Selwyn
DISTRICT
COUNCIL

Consent No. R417664

APPLICATION FOR BUILDING CONSENT
Section 33, Building Act 1991
(Cross each applicable box and attach relevant documents in duplicate)

Description of Work:
NEW RESIDENCE / ~~STORAGE BUILDING~~ ALTERATIONS

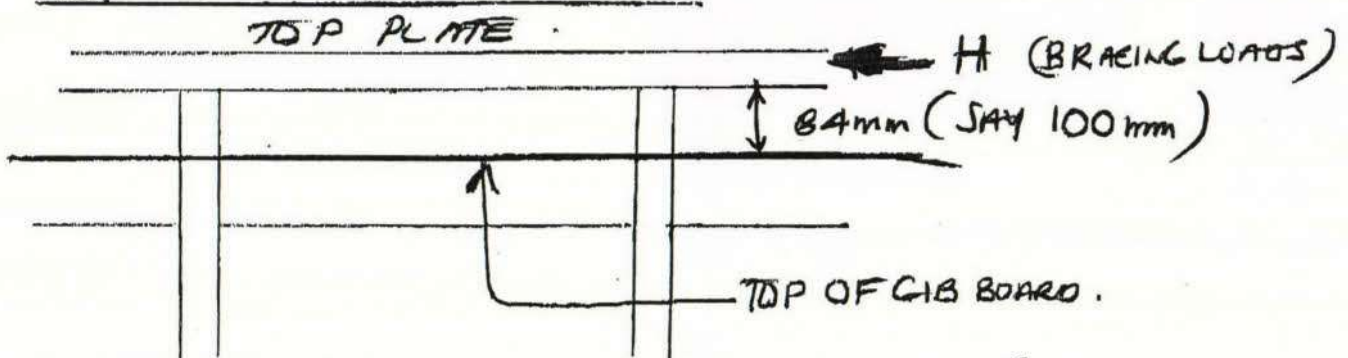
INTERNAL BRACING LINES COLONO.	SKETCH FORWARDED
- LIVING / DINING	7.8 m.
- BEDROOM 1 / BATHROOM	3.6 m
- BEDROOM 1 / GARAGE	3.4 m
	<u>4.2 m</u>
TOTAL INTERIOR = 19.0 m	
<u>DIAGONALLY</u> <u>BRACED WALLS</u>

BASED ON NES 3604: 1990, VALUES FOR
LET IN TIMBER BRACING, NOT ENTIRELY WITHIN
ELEMENT, i.e. TYPE 2 (b) (ii)

$$RATING = 47 \text{ BUS/m. (2.4 WALL)}$$

THEREFORE FOR 19.0 m WALLS, $47 \times 19.0 \times 2.4 / 2.5$

$$= \underline{857 \text{ BUS PROVIDED}}$$

(d) TRANSFER OF HORIZONTAL LOADS FROM TOP PLATE TO
TOP OF BRACING WALLS

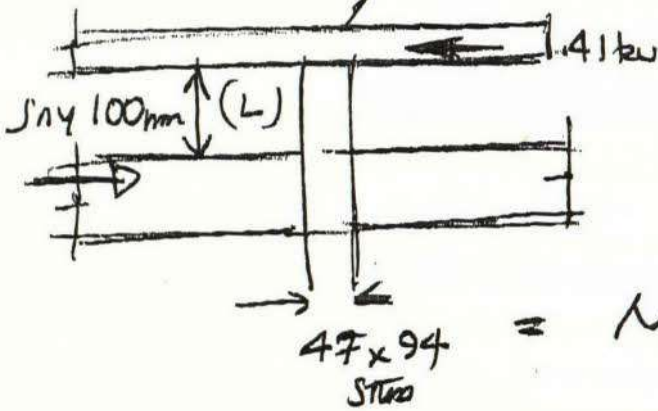
AT 600cms BRACING FORCE TO TRANSFER = $0.6 \times 47 = 28.2$ (PER STUD)

OR $28.2 / 100 \times 5.0 \text{ kN} = 1.41 \text{ kN (ULS)}$

$47 \times 94 = M^* = P \times L$
 $= 1.41 \times 0.1 = 0.141 \text{ kNm}$
(per stud)

$\gg 0.141 \text{ kNm}$ ✓ OK

"AMMENDMENT" LAYOUT DETAILS FOR
FRAMING ALTERATIONS & MULTI FUEL
BURNER INSTALLATION.

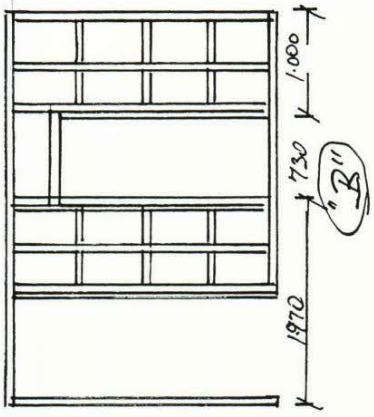
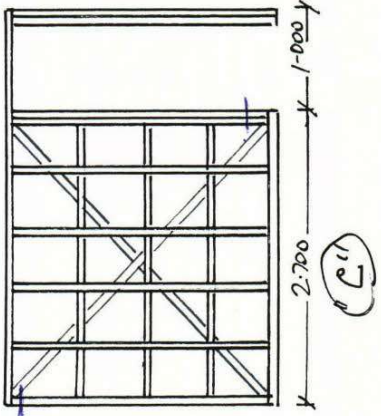
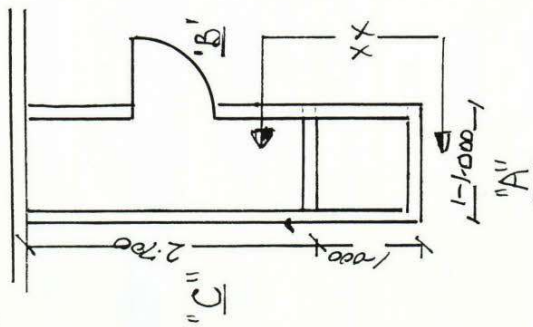
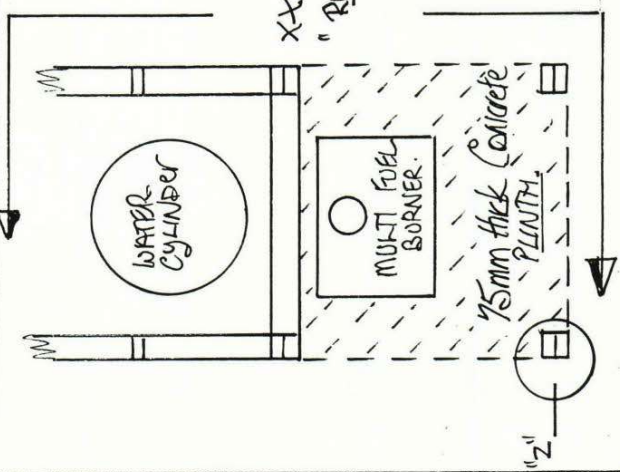
Please find enclosed details of an ammendment for the above building consent, to install a Multi Fuel Burner.

AMMENDMENT TO ORIGINAL PLAN
FOR DETAILS REFER SHEET No.2.

DETAIL "Z"

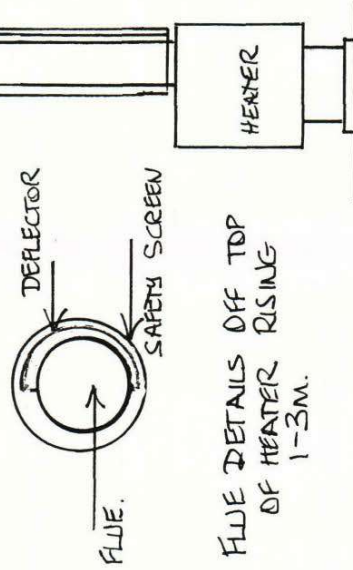
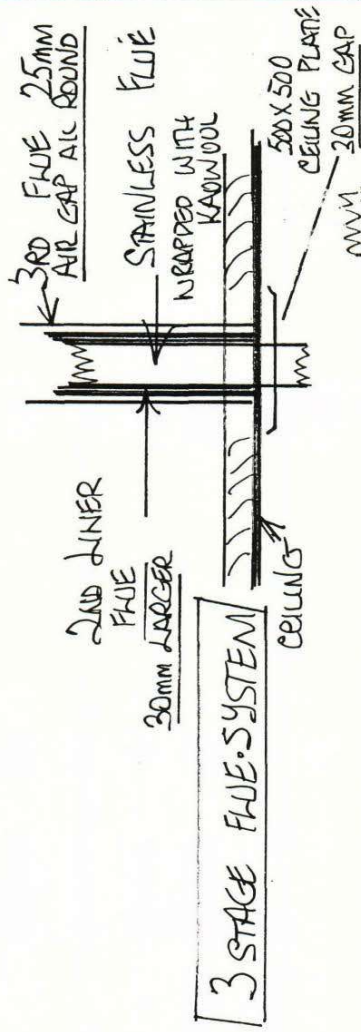
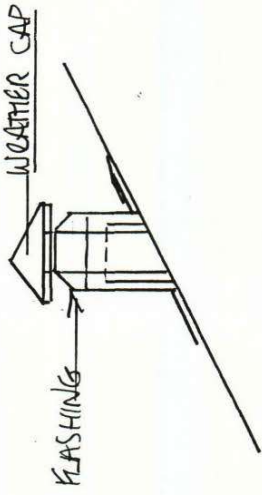
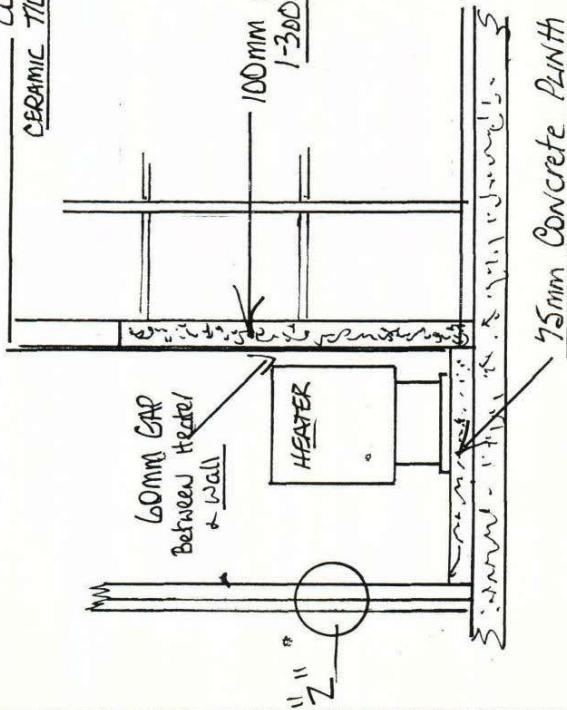
COMPLETE WALL & BASE CERAMIC TILED BEHIND HEATER.

100mm thick concrete wall 1-300 HIGH OFF PLINTH.

Amendment to Sewerage Treatment and
disposal System BUILDING Consent NO R 417664.

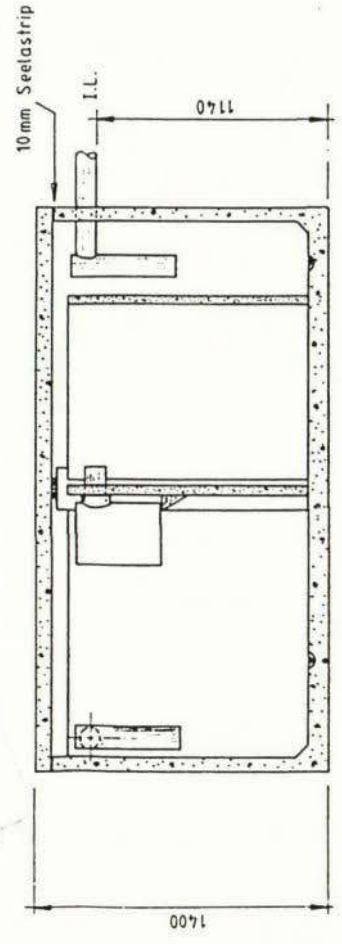
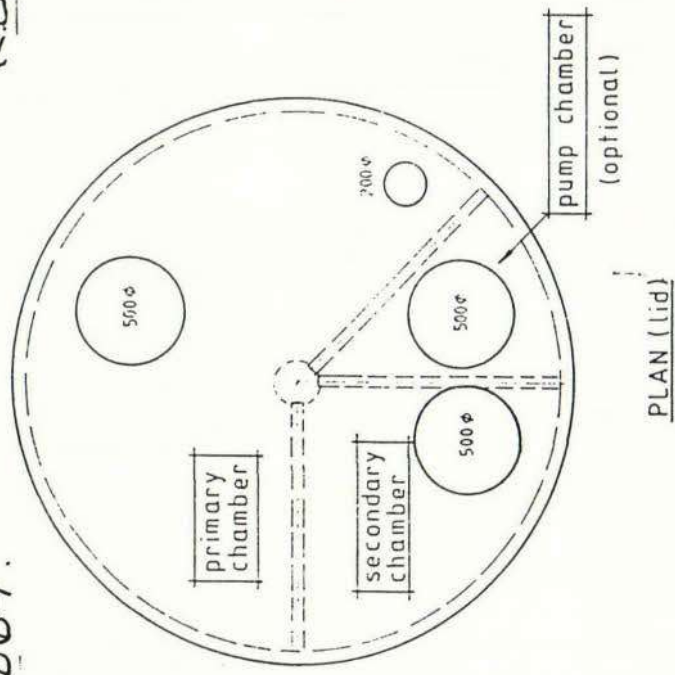
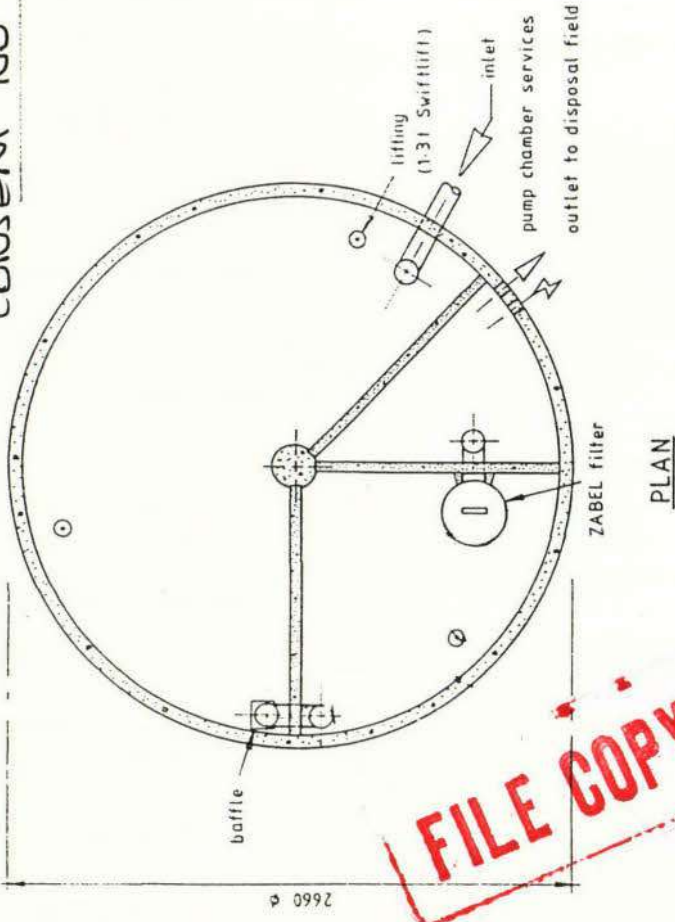
PLAN SHOWS "HUMES" RD 5000 SEPTIC TANK
PLEASE Note! this unit will NOT now be used.

AMENDMENT ___ MCKENDRY Z / 5000
SEPTIC TANK WITH ZABEL FILTER WILL BE INSTALLED.
